TO: Khadeja Sarwar, Atwell, LLC
FROM: Amber Wood Hicken, Planner I
DATE: 7/21/25
SUBJECT: Parker Pointe, Black Rock Coffee, Site Plan
Review Comments 03

LOT 4A, PARKER POINTE SUBDIVISION FILING NO. 1, AMENDMENT NO. 1

SITE PLAN FOR

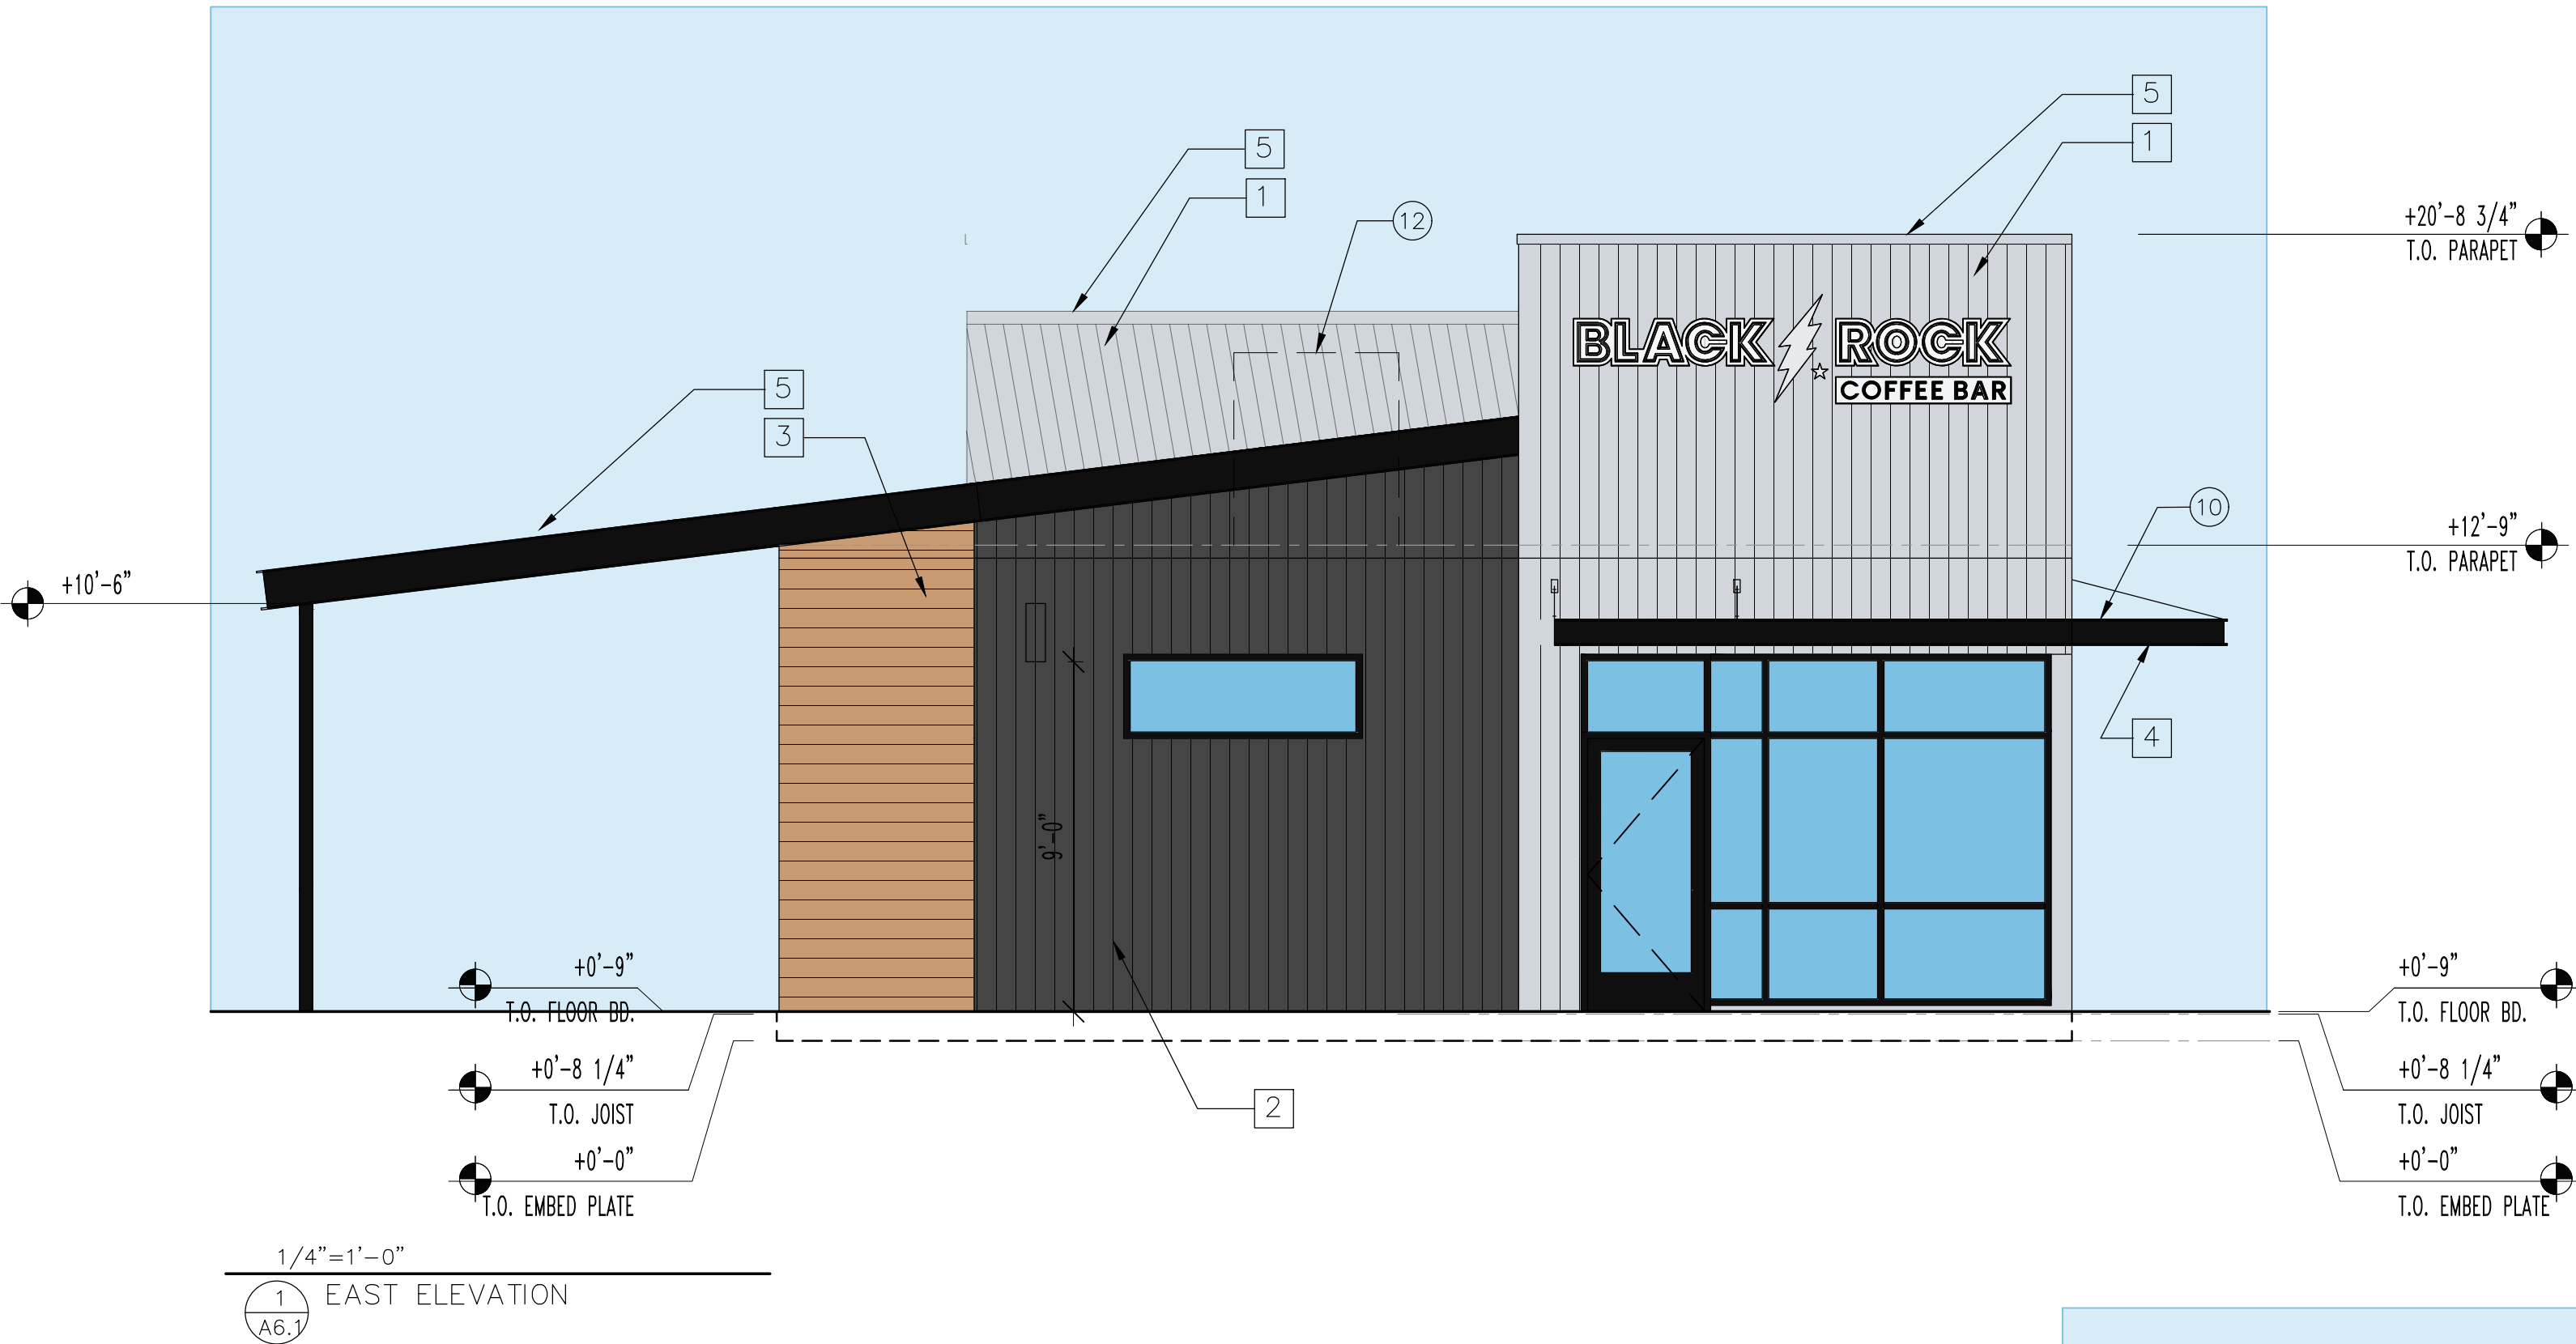
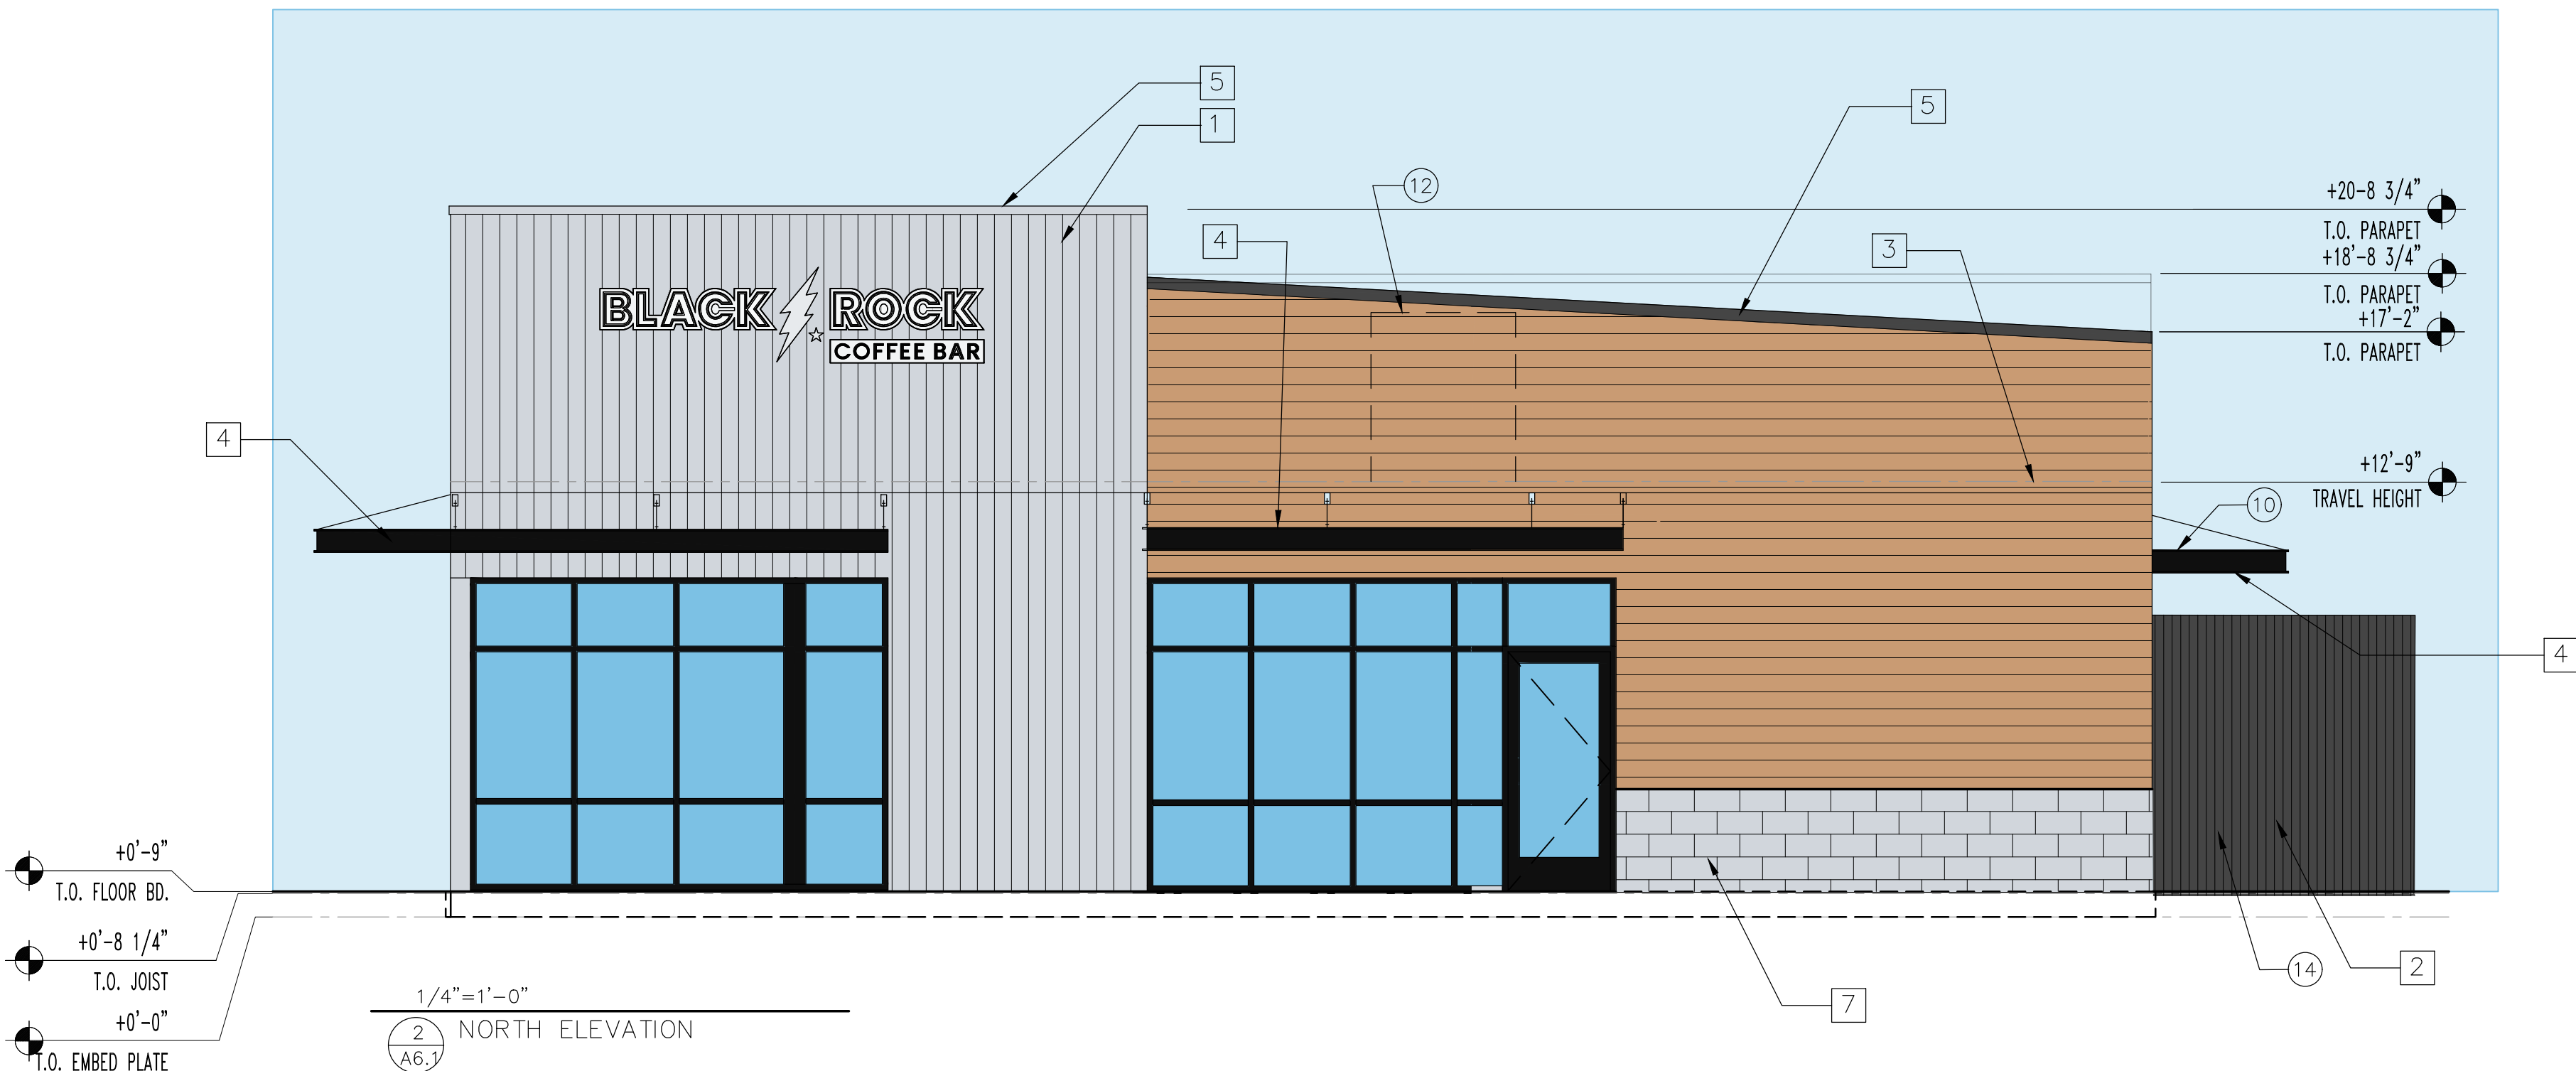
show transparency calculations
for these facades

east - 25%
north - 40%
